CITY OF ALBUQUERQUE

**Planning Department
Transportation Development Services Section**

Re: Certification Submittal for Certificate of Occupancy for
6811 Huseman
Engineer's Stamp dated 09-06-11 (M10-D016H)
Certification dated 12-28-12

**Re: Lot 2 Coors Arenal Industrial Park, 6811 Huseman Pl SW,
Request for Permanent C.O. –Accepted
Engineer's Stamp dated: 10-10-11, (M10/D016H)
Certification dated: 12-26-12**

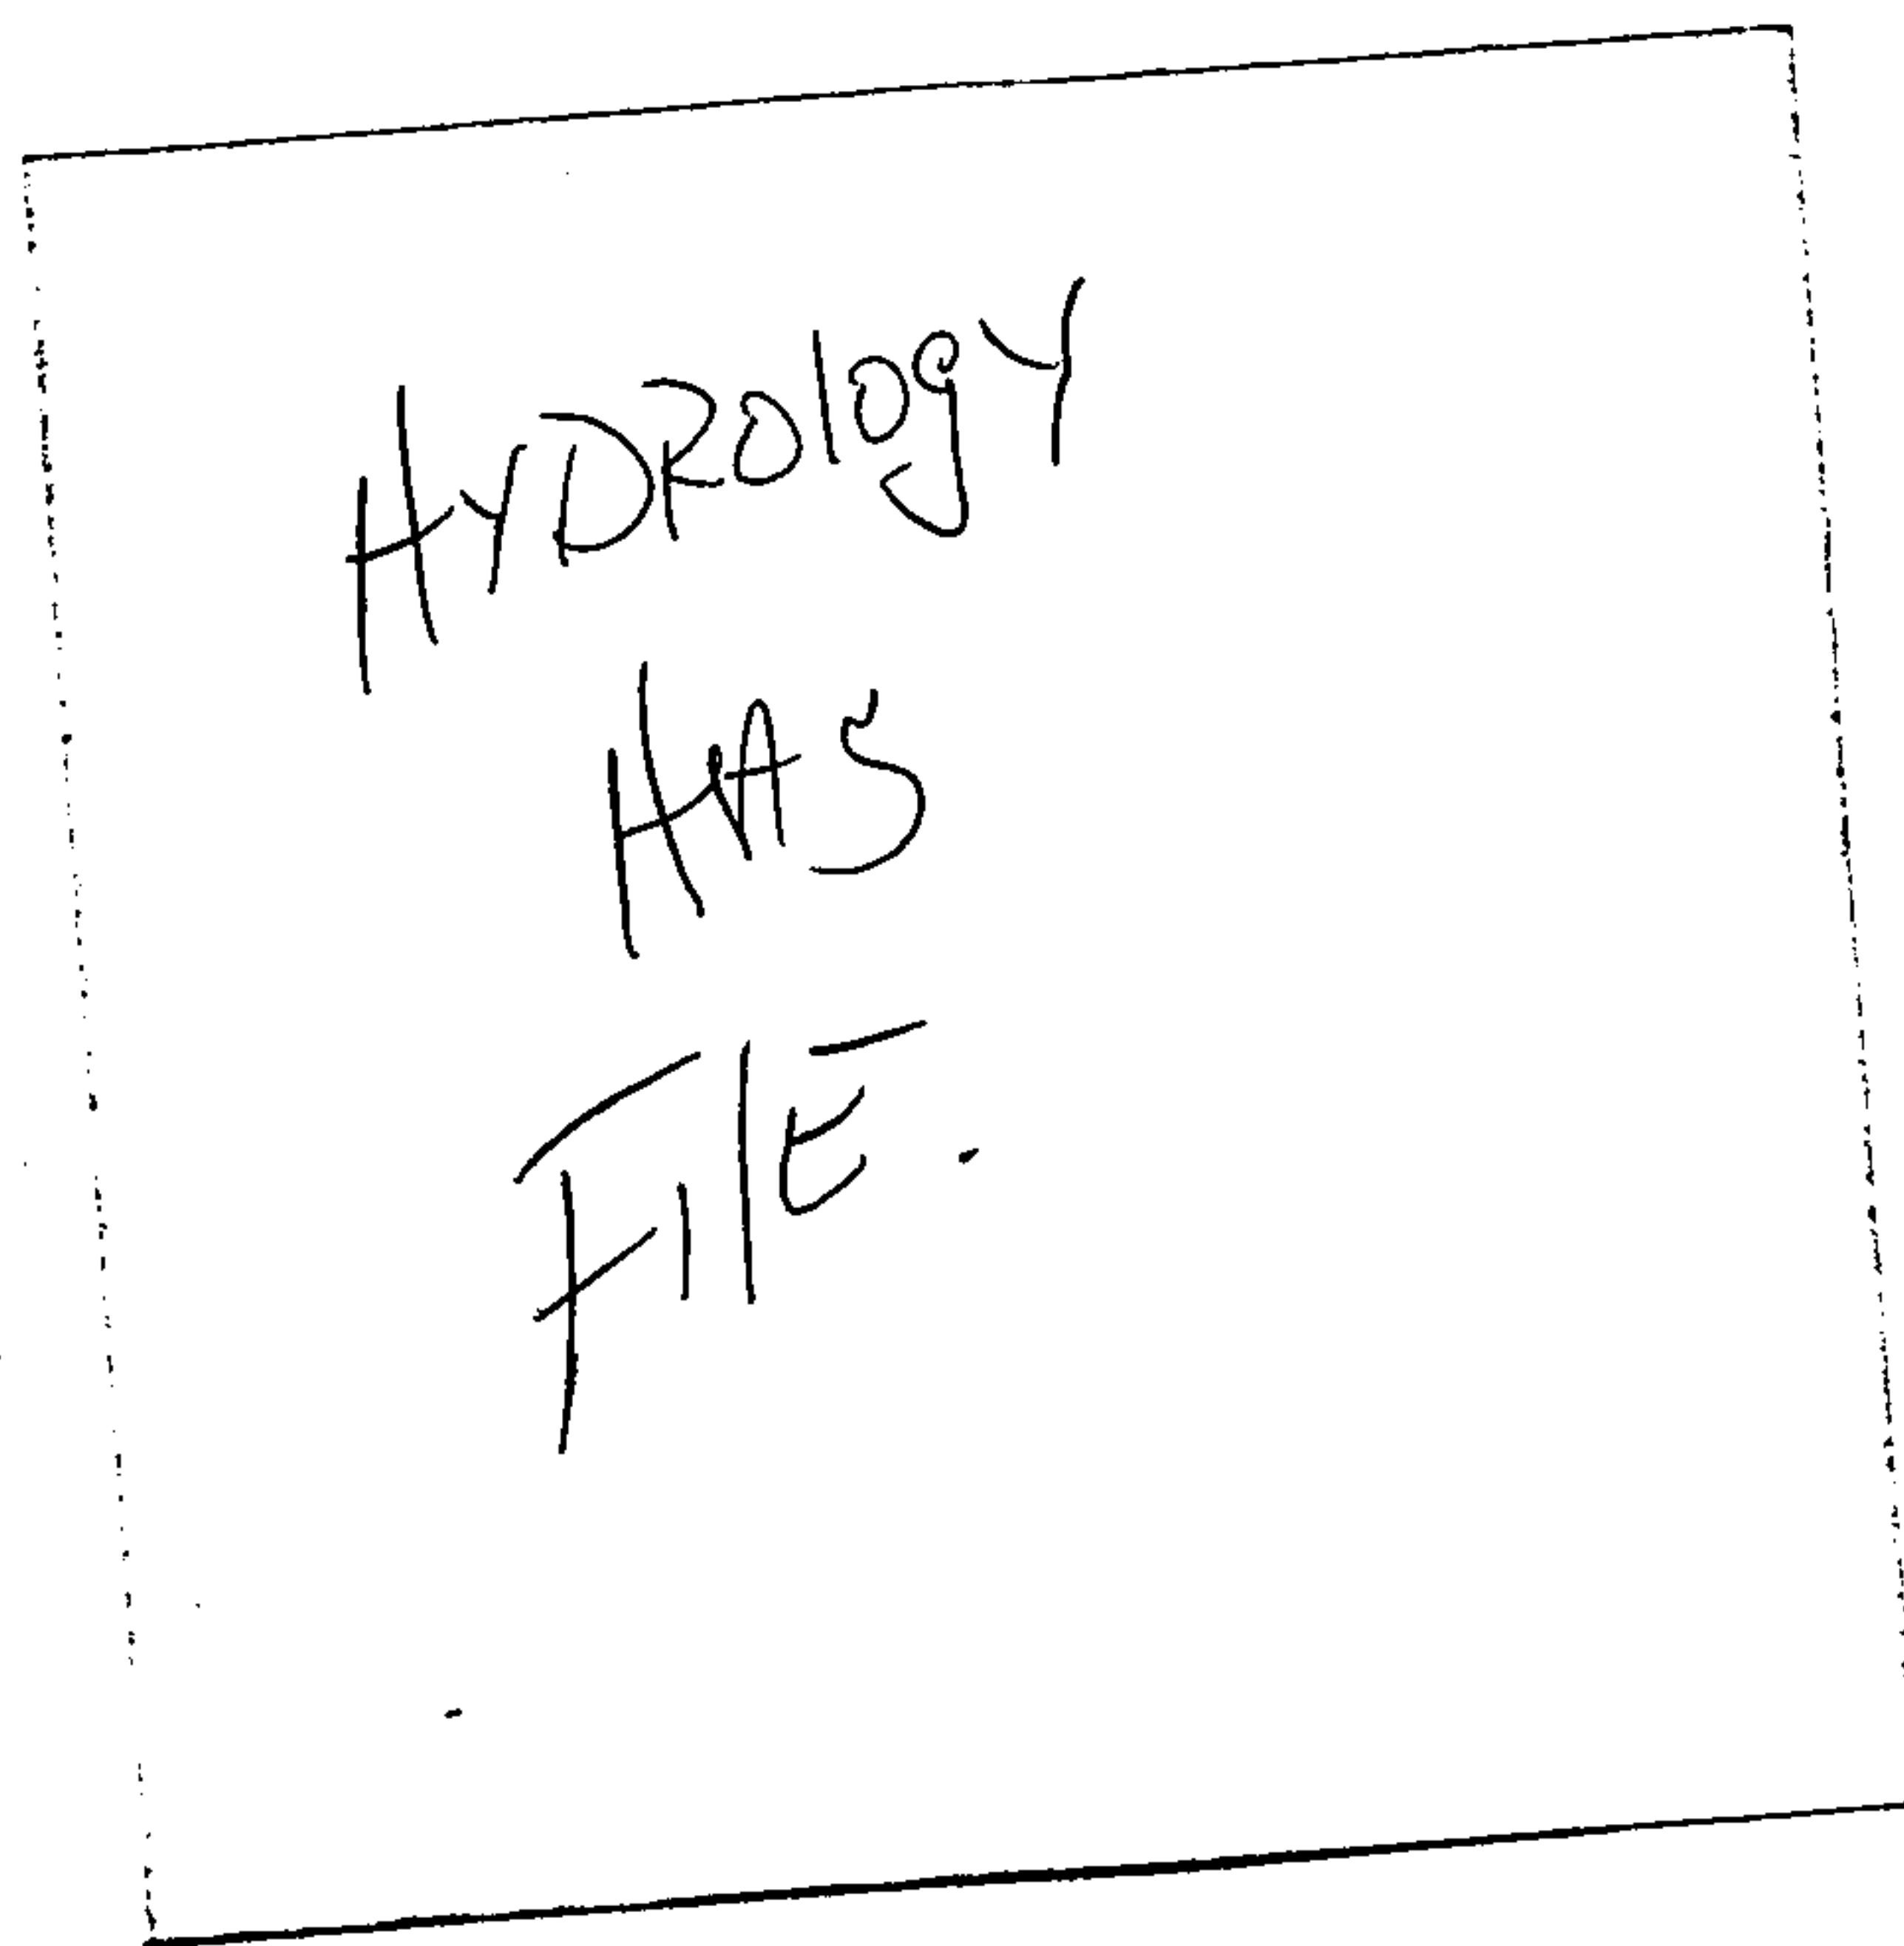
- Is a 6 foot pedestrian connection from the public sidewalk to the building entrance required by zoning? If so, the pedestrian connection labeled on the submitted site plan does not comply with DPM standards.

- The pedestrian connection must be ADA handicap accessible.
 - There is a section of pathway missing between the public sidewalk and the asphalt pedestrian connection.

- A metal fence obstructs access from the public sidewalk to the pedestrian connection. Please provide a handicap pedestrian accessible gate.
 - Per the DPM, the pedestrian connection must be a separate sidewalk, six feet in width, unobstructed and clearly demarcated. The pedestrian connection provided is the last 6 feet of the asphalt drive aisle/ parking area demarcated with a single, white, 4 inch wide, paint strip. The edge of the pedestrian connection drops off onto dirt without a header curb to maintain a firm path. The parking areas drainage runoff is sloped to run directly across the pedestrian connection. Please provide a pedestrian connection per DPM and ADA standards.

- The approved TCL does not show a street frontage fence, fence posts and locking gates across drive pad. Please provide site plan with all changes to approved plan.
- The new public sidewalk shows a tie-in to an existing sidewalk at the east frontage. Please correct site plan to reflect accurate conditions.

Is ped connection req?

Needs to be hadlined

- missing section
- no ped gate
- need to be sep by SW
(per DPM)

Show fencing / gate
